RIVERWOOD SUBDIVISION

APPLICATION NUMBER 27 DATE May 6, 2004

DETAIL SITE PLAN

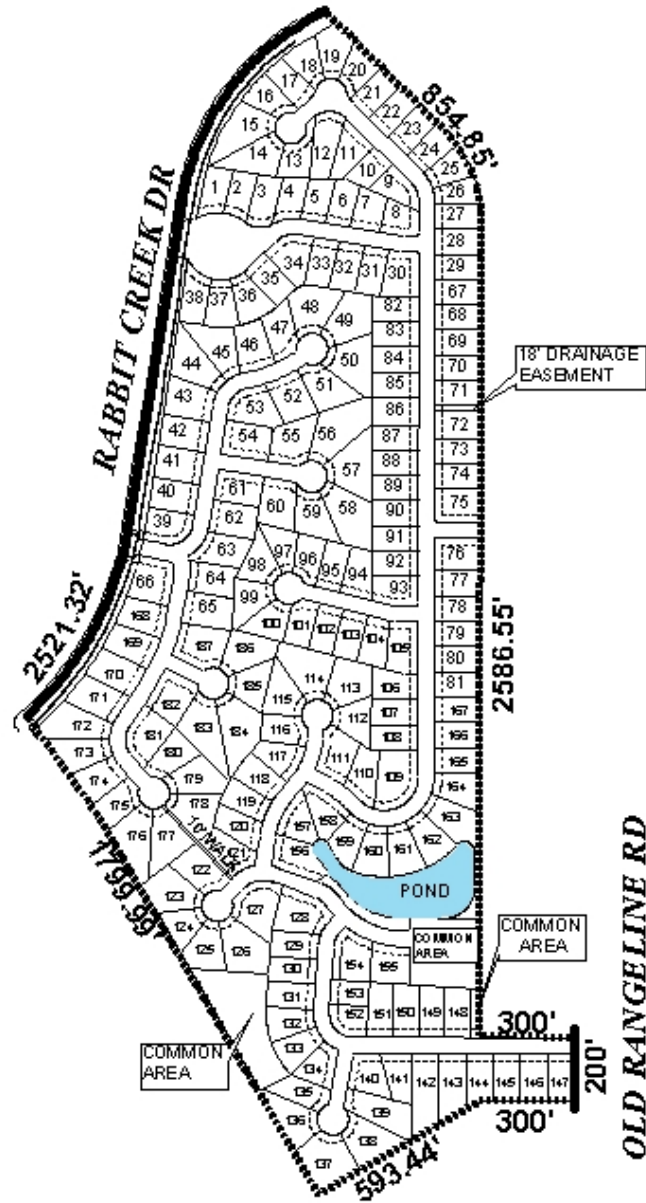
During the review process of this application it was discovered that there were problems with the legal description and that the proposed subdivision included a portion of a lot, but not all of it. The applicant's engineer was contacted regarding these issues. A revised drawing illustrating the boundaries of the remainder of the omitted partial lot was submitted; however, it was not included in the legal description, nor was it indicated as a lot or as future development. As with any subdivision application, entire properties must be included when part of the property is involved.

While the general configuration and lot sizes appear to comply with the Subdivision Regulations, there are several other points of concern that should be addressed. The plat illustrates several areas that are either not identified or are identified as a sidewalk path. These areas must be accounted for, identified and appropriately labeled. Also, a note should be placed on the plat indicated that maintenance of these areas shall be the responsibility of the property owners.

Also, the plat does not reflect the required minimum building setback line.

Based on the preceding, it is recommended that this application be heldover until the June 3 meeting to allow the applicant to submit a revised plat to address the concerns expressed in the staff report, and to include the remainder of all property(s) involved in the application.
